Narrative Testimony for the M3 Eagle Water Right Application

Dennis Owsley

May 11, 2009

This narrative testimony was developed in response to the April 1st memo prepared by HLI in response to our March 2nd Staff Memorandum. I co-authored the March 2nd Staff Memorandum and appreciate this opportunity to provide testimony in response to the comments provided by HLI in the memo.

Figure 3-4: Subdivisions of Idaho Group sediments.

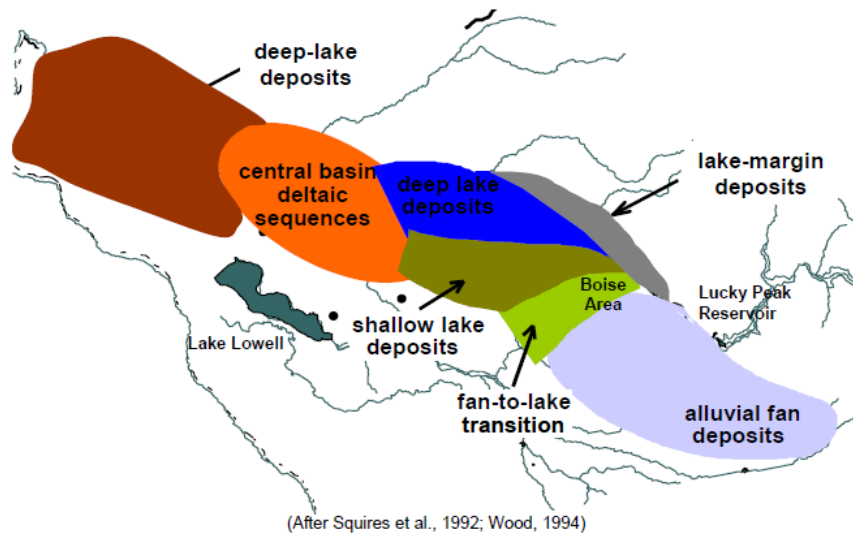
This slides shows Figure 3-4 of the Exhibit 33D. This figure depicts the Subdivisions of the Idaho Group Sediments in the Treasure Valley after Squires, et al 1992 and Wood 1994.

These subdivisions of the sedimentary units is supported through the data and testimony submitted in support of this water right application. Note the gray lobe on the northeast side of the group of classifications. This gray shaded area represents the lake-margin deposits, which would include the deltaic sands of the Pierce gulch Aquifer. The limited extent of the these lake-margin deposits supports the earlier testimony I provided that the lake-margin sediments merge into the finer grained deposits within the basin. This depiction of the sedimentary units within the Treasure Valley indicates the lake-margin deposits are not as extensive as conceptualized by HLI.

Cross Section 4

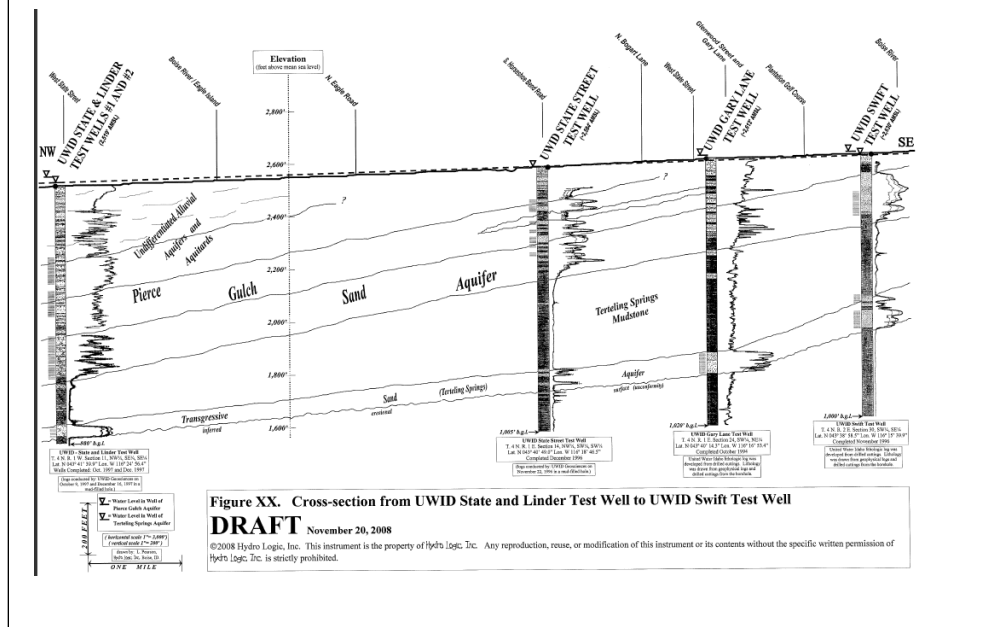
This slide shows one of the submitted cross sections developed by HLI in exhibit 26. With respect to PGSA exposure under the Boise River, HLI states on page 28 of Exhibit 45 that the geophysical signature of the Swift well represents the PGSA 400 feet beneath the river. According to this figure, the PGSA is depicted from approximately 75 feet to 225 feet below the Boise River. This inconsistency questions the certainty of identifying this interval of this well as PGSA. In addition, the region identified as the PGSA in the two central wells of this diagram is not distinguishable from the undifferentiated alluvial aquifers and aquitards in the upper left section of this diagram.

Figure 46. Comparison of Pierce Gulch Sand Aquifer Water Levels in M3 On-Site and State and Linder Wells

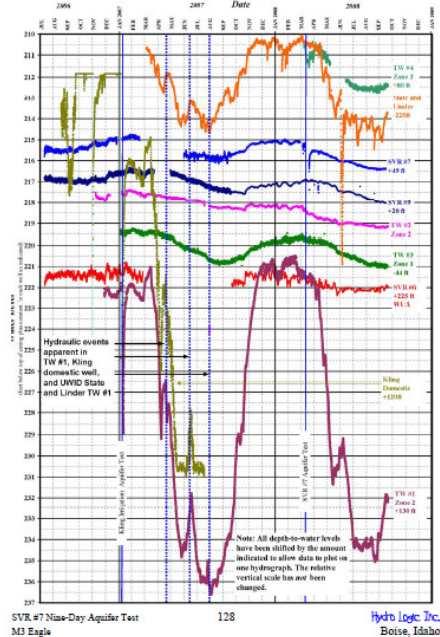
First, I would like to point out four wells that all show a similar downward trend over the past three years of monitoring. The wells are SVR #7, SVR #9, TW#2, and TW#3. They are the two blue plots and the pink and green plots on the graph. These wells are all located in the central A close visual inspection of the water levels from these four wells on the M3 property shows a declining trend over the past few years. This trend is interesting, considering the testimony that water levels are rising down in the valley in wells believed to be completed into the same aquifer.

Next, I'd like to point out two more wells on this graph. The wells are United Water State and Linder Test Well and the Tw#1. These wells are represented by the orange plot (the united water well) and the maroon plot (TW#1) on the graph. Notice the significantly different seasonal water level fluctuation exhibited in these wells when compared to the first four. TW#1 is located down in the southwest portion of the "panhandle" section of the property. United Water State and Linder well is located near the intersection of State Street and Linder Road. The department noted this change in water level fluctuations in the staff memorandum and HLI responded on Page 20 of Exhibit 45

The staff did not ever imply that the two groups of wells were in separate geologic units. This difference in fluctuations does not support HLI's claim that the fluctuations are due to the proximity of the pumping centers, or one would expect the State and Linder monitoring well would have a greater response to such pumping than TW#1. The response by HLI is not supported by the data presented Figure 46, as the seasonal fluctuations in the State and Linder (closer to the pumping wells) are approximately five feet, whereas the same seasonal fluctuations in TW#1 are on the order of 16 feet.

Figure 27

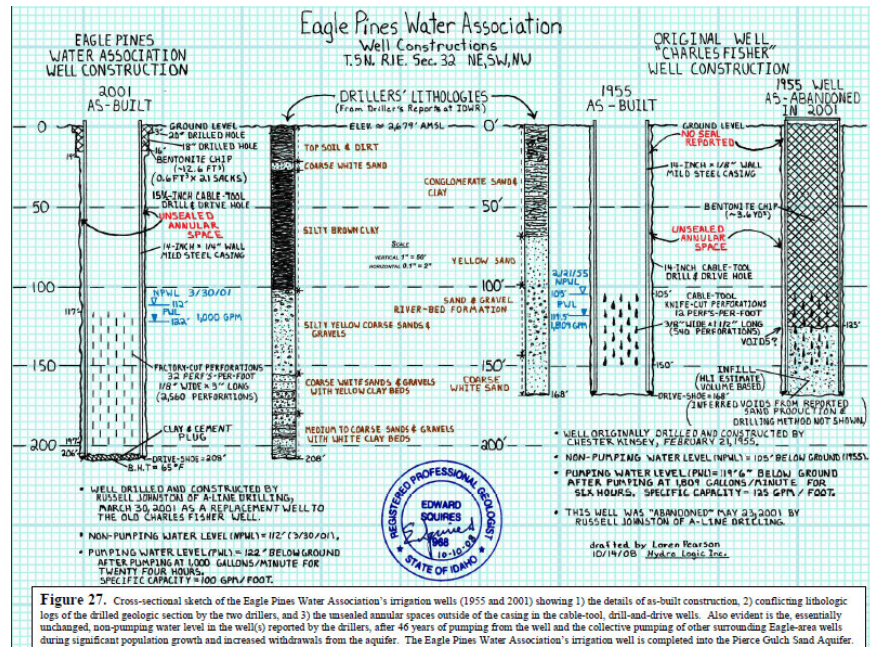
This slide shows figure 27 of Exhibit 45. This figure depicts the Eagle Pines Water Association old and new irrigation well diagrams. Note the annular seal on the both wells is identified as “Unsealed Annular Seal”.

By referring to the water levels in this well that is identified by Mr. Squires as unsealed, HLI is not consistent with their previous statements regarding the use of data from unsealed wells.
